Record of Decision for Installation Restoration Site 1, 1943-1956 Disposal Area, Alameda Point, Alameda, California

RESPONSE TO COMMENTS

RESPONSE TO COMMENTS ON

Figure 3. Typical Cross Section of OPEN CELL WIB

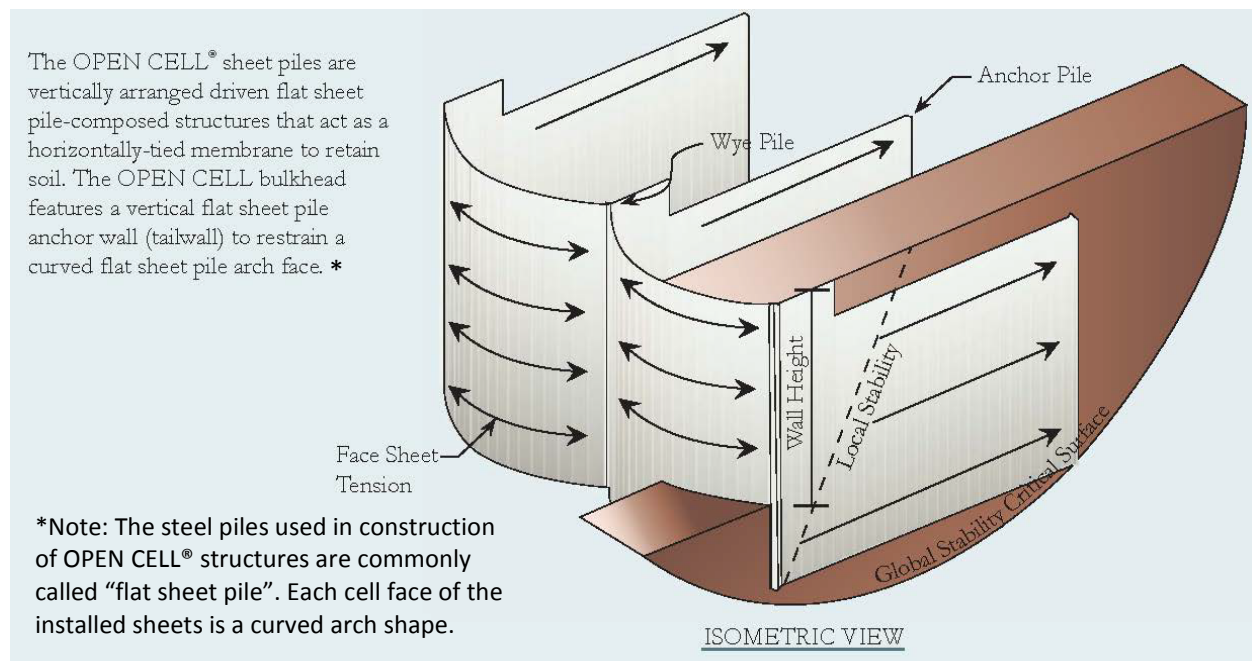
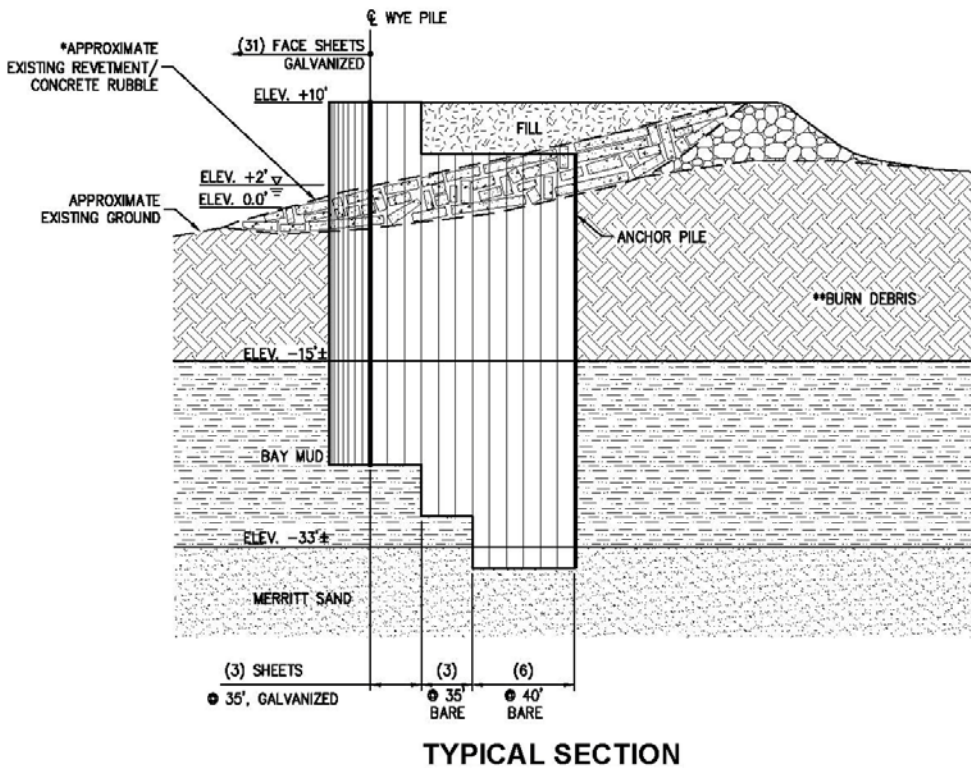
| 7 | <p>Soil remediation Alternative S1-4a includes the installation of an Open Cell non-galvanized steel sheet pile bulkhead to provide bracing along the shoreline during excavation that would remain in-place after excavation and backfilling operations are completed due to costs associated with the removal, decontamination, and confirmatory sampling of the steel sheets. However, according to the Alameda IR Site 1 OPEN CELL WIB – Corrosion Protection Design Memorandum presented in Appendix F an untreated steel sheet pile system has an expected life of only 32 years. Additionally, no inspections or</p> | <p>The last sentence of the second paragraph of Section 6.2.1.2 which reads:</p> <p><i>The steel bulkhead would remain and not be removed because of the cost associated with removal, decontamination, and confirmatory sampling of the steel sheets.</i></p> <p>will be stricken and replaced with the text that follows:</p> <p><i>The shoreline slope with revetment will be returned to its angle and condition prior to excavation. The steel</i></p> |

| | <p>maintenance activities and costs are included in Table 6-1 (Cost Estimate Summary Burn Area Aspects of Alternative S1-4a). The Draft FFS does not adequately address the potential issues that could arise by leaving an untreated steel sheet pile wall in-place at the site, such as a deteriorating or failing wall that presents safety hazards (the proposed land use for IR Site 1 is recreational) due to lack of inspection and maintenance over time. Please revise the Alternative S1-4a to include additional consideration for the remaining steel sheet pile wall or its removal. Alternatively, at a minimum, please revise the Draft FFS to include information addressing the concerns by leaving the steel sheet pile wall in place.</p> | <p><i>sheet pile extending above the restored slope will be cut off at ground surface following the restoration of the shoreline slope. The subsurface steel sheet pile will remain in place.</i></p> |

Figure 4. Borings and Trenches Location Map (AMEC, 2012)

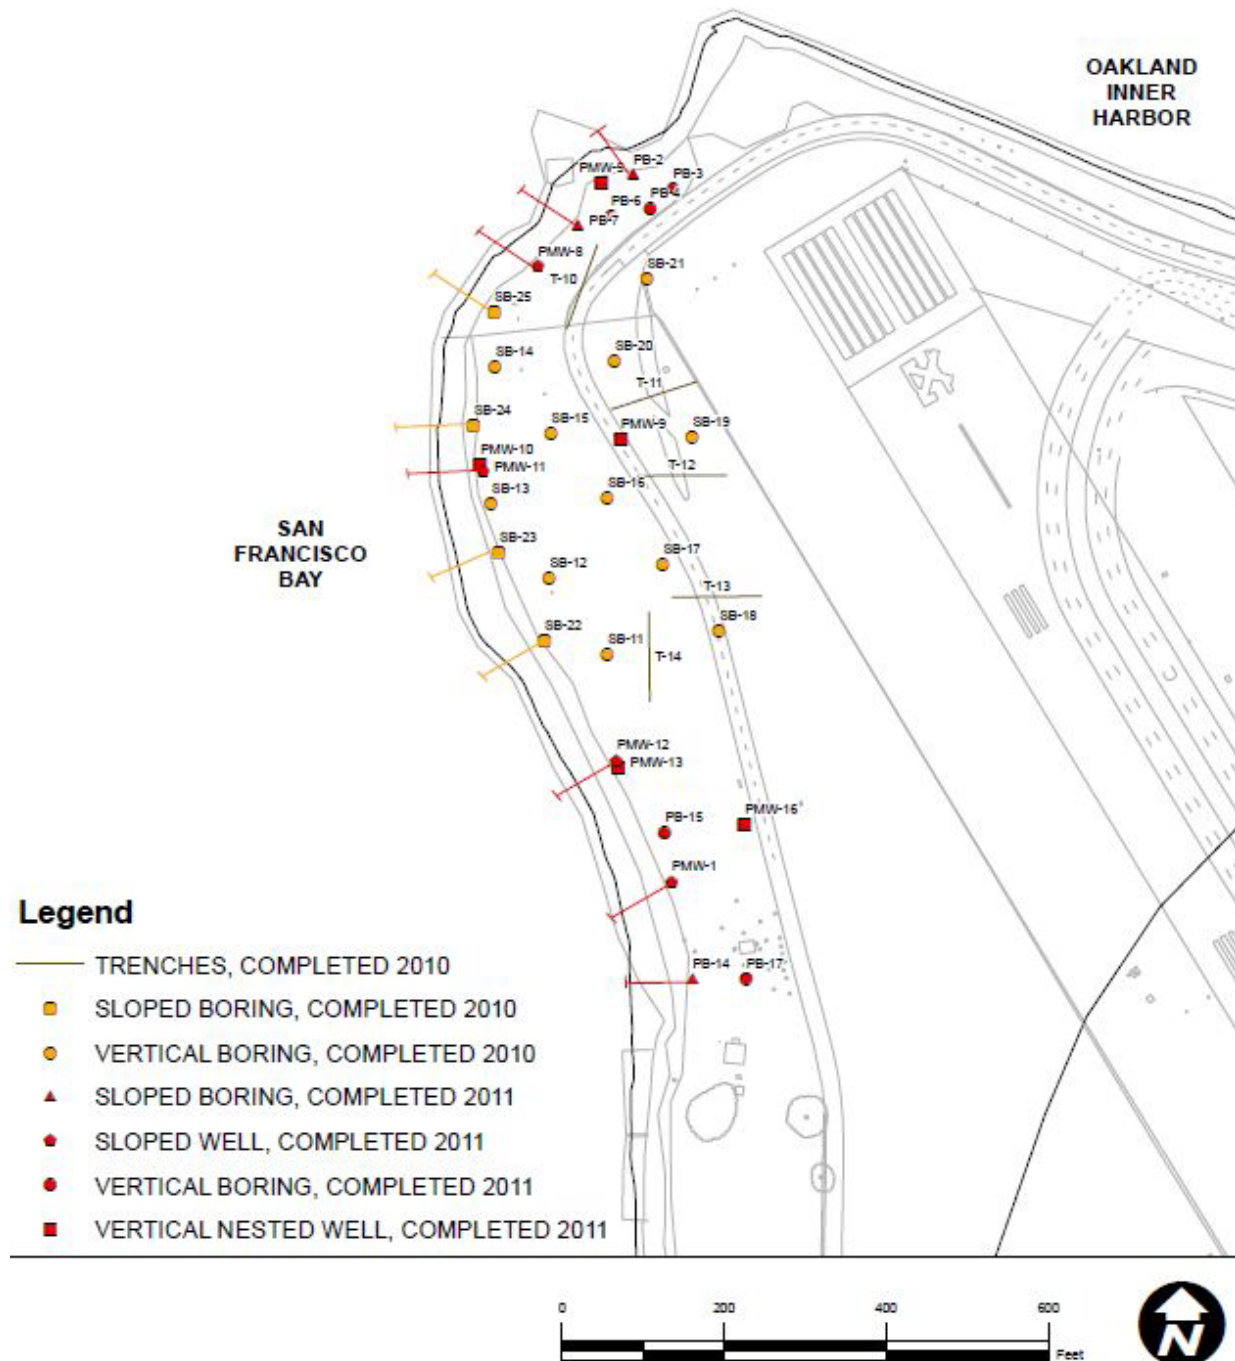
| 8 | <p>The level of detail provided in Table 6-1 (Cost Estimate Summary for Burn Area Aspects of Alternative S1-4a) and Table 6-2 (Cost Estimate Summary for Burn Area Aspects of Alternative BA-1) is insufficient to demonstrate the level of effort necessary to implement each of the alternatives. For example, on Table 6-2, the total cost to inspect and maintain the waste isolation bulkhead (WIB) is listed as a lump sum of \$970,000 over 30 years; however, it is unclear what is included in the lump sum cost. Vendor quotes and engineer's estimates should be provided to support the cost-breakdown. Also, the Alameda IR Site 1 OPEN CELL WIB – Corrosion Protection Design memorandum presented in Appendix F recommends additional soil sampling for pH and resistivity to determine if a corrosion preventative coating should be applied to the land side of the steel sheet piles. It is unclear whether Table 6.2 includes the additional costs associated with this soil sampling. Please revise the FFS to include the detail and specificity requested in order to demonstrate an understanding of the complexity of the proposed remedial alternatives. Further, please provide vendor quotes and engineer's estimates to support the costs.</p> | <p>Backup information for cost estimates has been added to Appendix G. Specifically, the example for total cost to inspect and maintain the WIB was refined by PND Engineers in their technical memorandum on Corrosion Protection Design.</p> <p>Select soil samples from borings advanced at an angle under the shoreline slope were analyzed for pH, chloride, and sulfate. Results from these analyses were used to augment the information provided in the Corrosion Protection Design memorandum, which now includes a section of soil test analysis results.</p> |
